BOARD OF TRUSTEES
Regular Meeting Agenda
205 East State Street
July 21, 2026 12:00 Noon

CHANGE ORDER NO. 2

Owner:	Marshalltown Water Works	Owner's Project No.:	
Engineer:	HDR	Engineer's Project No.:	10352507
Contractor:	Shank Constructors	Contractor's Project No.:	1329
Project:	10352507 – 1329 MWW RO Membrane Treatment Process Train		
Contract Name:	Marshalltown Water Works Reverse Osmosis Membrane Treatment Process Train		
Date Issued:	07/17/2026	Effective Date of Change Order:	07/17/2026

1. SHEET 01D319 – 10" DECANT INTAKES AND BYPASS – PLAN AND PROFILES

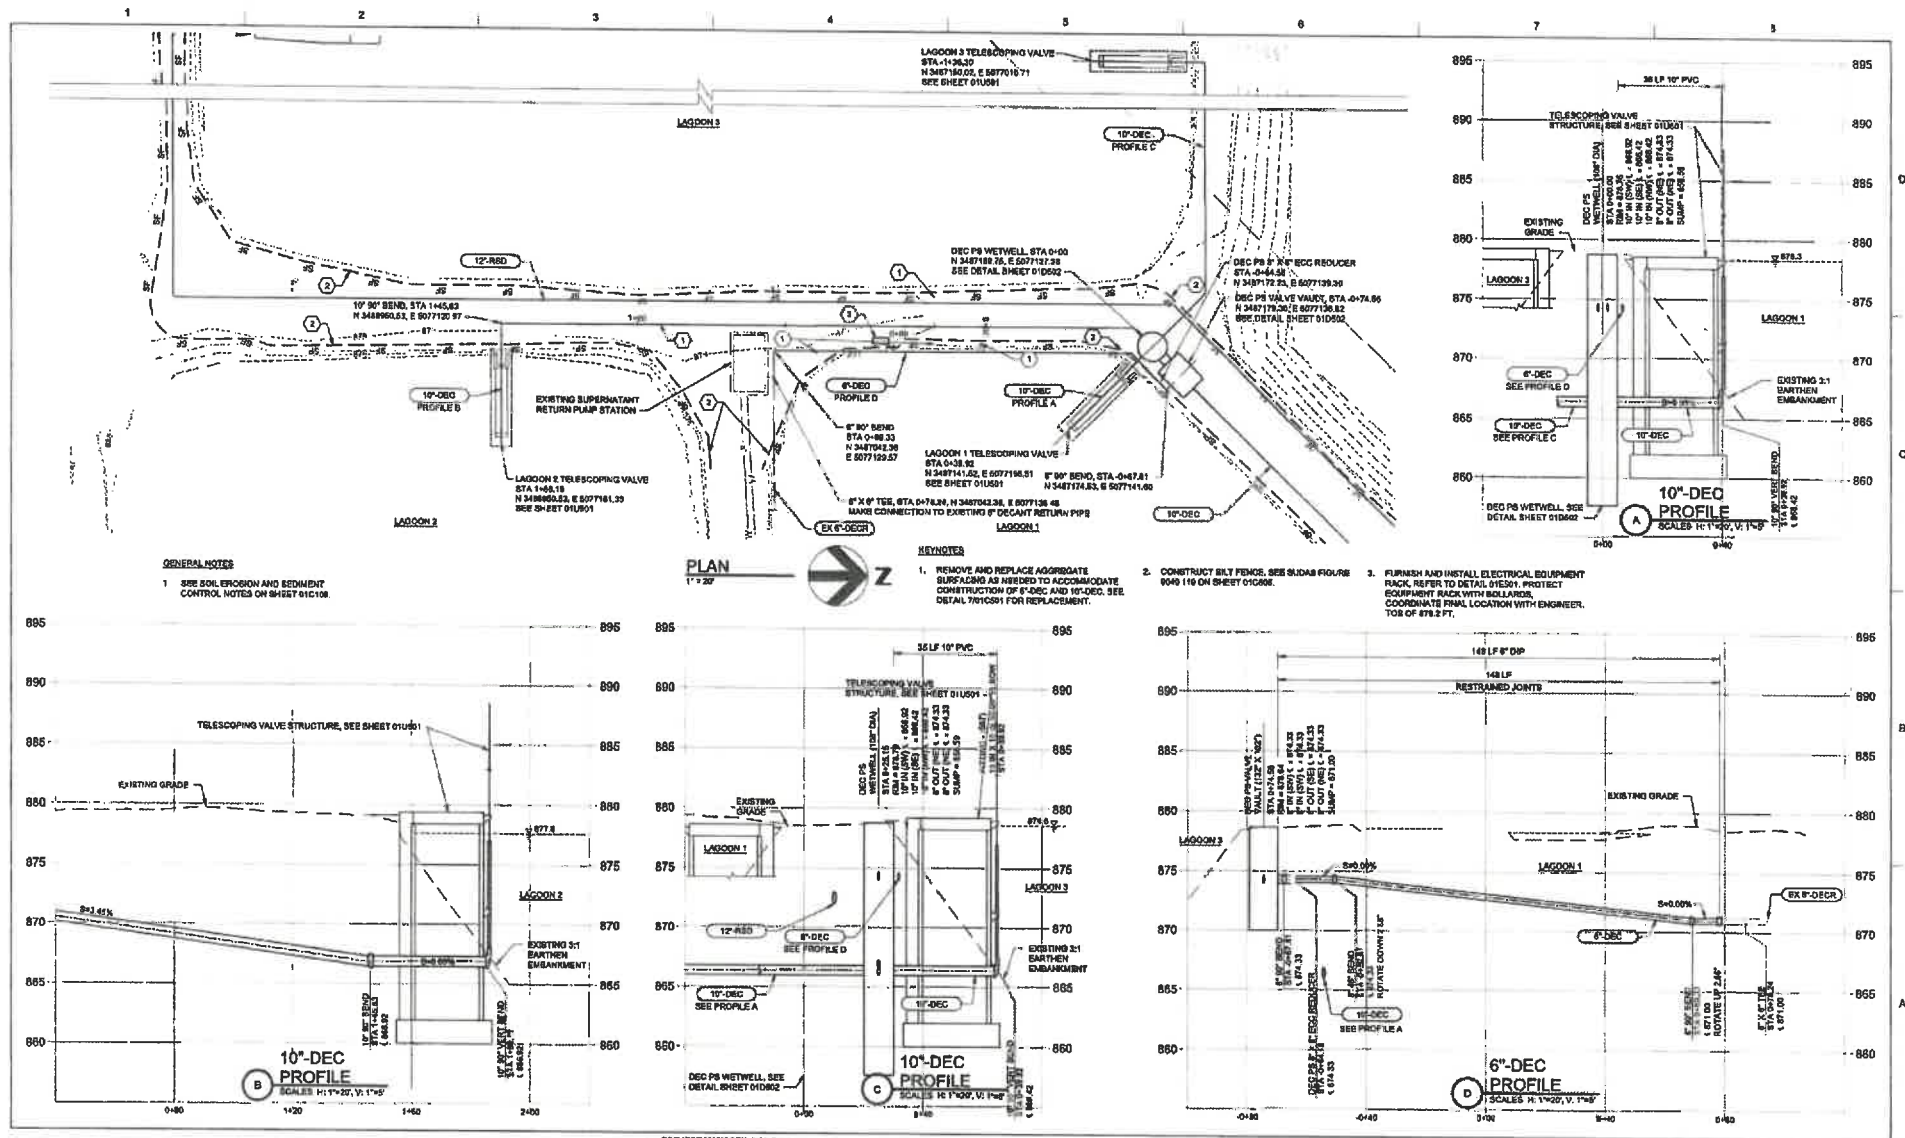
1. *Shank Constructors - Cost Increase for additional excavation, material, equipment and labor required to complete work change depicted on 01D319.*

1. *Shank Constructors – Added 140’ of 10” Restrained Joint Ductile Iron Pipe, 10” MJ Bends and Restraint DIP and associated additional excavations, materials, equipment and labor.*

This field order serves to align the attached sheet with what is being shown in the conformed set. The sheet currently shown in the conformed plans is identical to the one attached to this field order. This update ensures the plans reflect the intended revisions from Addendum E.

HDR has completed its review of Change Proposal No. 004 (PCO#004) submitted by Shank Constructors in response to Field Order No. 3 for Sheet 01D319 – 10-inch decant intakes and bypass plan and profiles and **recommends acceptance.**

PCO#004 reflects costs associated with implementing revisions directed by Field Order No. 3, which modified the Contract Documents to align design intent and required configuration of the decant intake and bypass system. The proposed scope and associated costs are consistent with the directed changes and are supported by the submitted breakdown of labor, materials, and equipment.
